# **Provisioning of LLIDs, UNI Ports, and Queues**

# Proposal #1a – TLV for *acConfigLlid* Action

Figure 6-2—Unidirectional (downstream) unicast connectivity

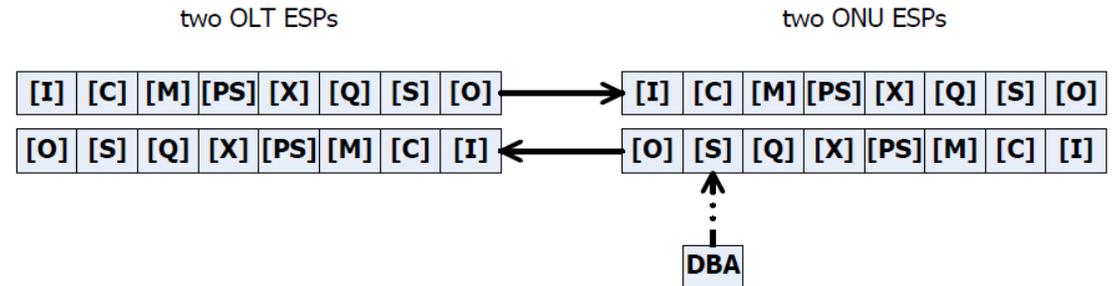
Per EPON Reference Model in 1904.1, the EPON Service Path (ESP) consists of the following logical blocks:

[I] -- Input block	[X] -- CrossConnect block
[C] -- Classifier block	[Q] -- Queues block
[M] -- Modifier block	[S] -- Scheduler block
[PS] -- Policer/Shaper block	[O] -- Output block
